**RE: CHANGE ORDER NO. 6
ADDITIONS AND ALTERATIONS TO
HURRICANE DECK ELEMENTARY
CAMDENTON R-III SCHOOL DISTRICT**

**Change Order No. 6
Attachment**

**PROPOSAL
REQUEST**

PROPOSAL REQUEST NO.: 23
(twenty-three)

SD-A01

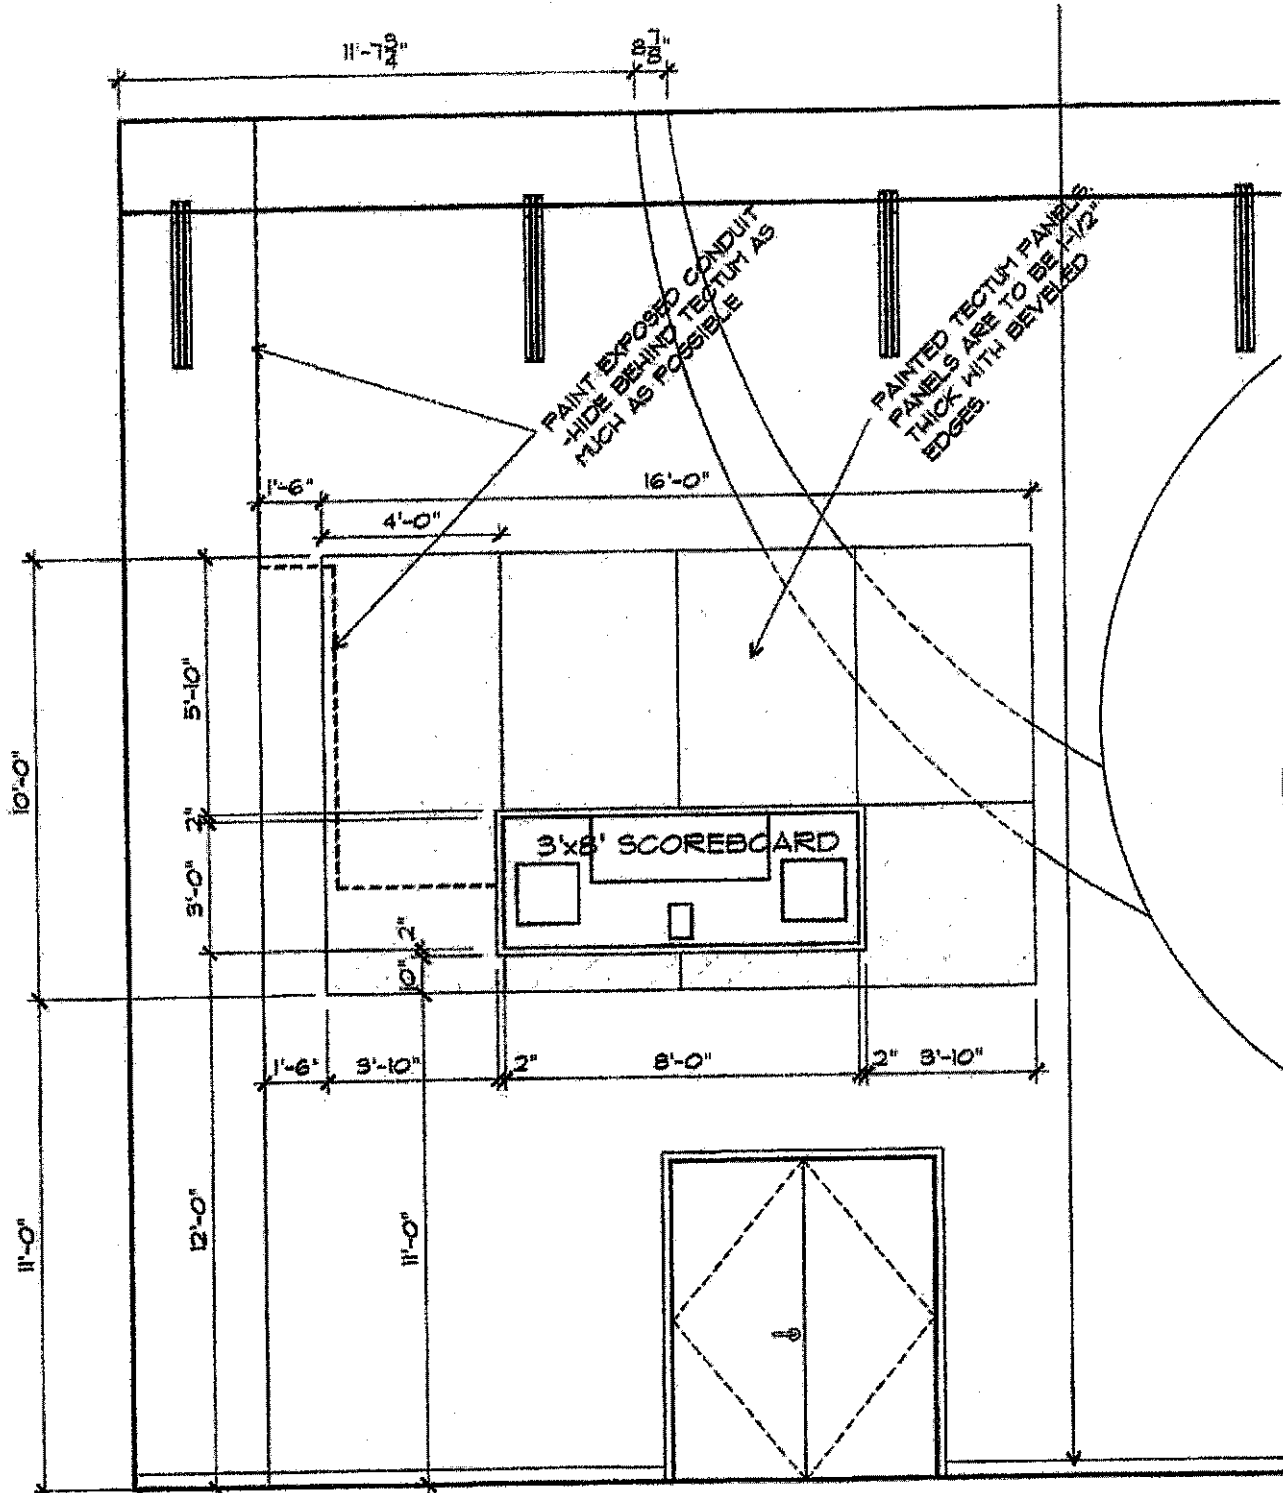
PLEASE ADVISE PLACEMENT OF
SCOREBOARD AND CONFIRM
POWER REQUIREMENTS &
CONDUIT ROUTING. THIS INFORMATION
IS NOT SHOWN ON
THANKS, THE ARCH & ELEC PLANS
(THAT I CAN FIND)

Refer RFP #23
Place bottom of Scoreboard 12'-0" above finish floor level. Refer to Proposal Request No. 23 (power to scoreboard). See Sheet SD-A01 dated 5/11/15 and RFP 23 /SDE5-3

1 GYMNASIUM 125A
 1/4" = 1'-0" WEST WALL
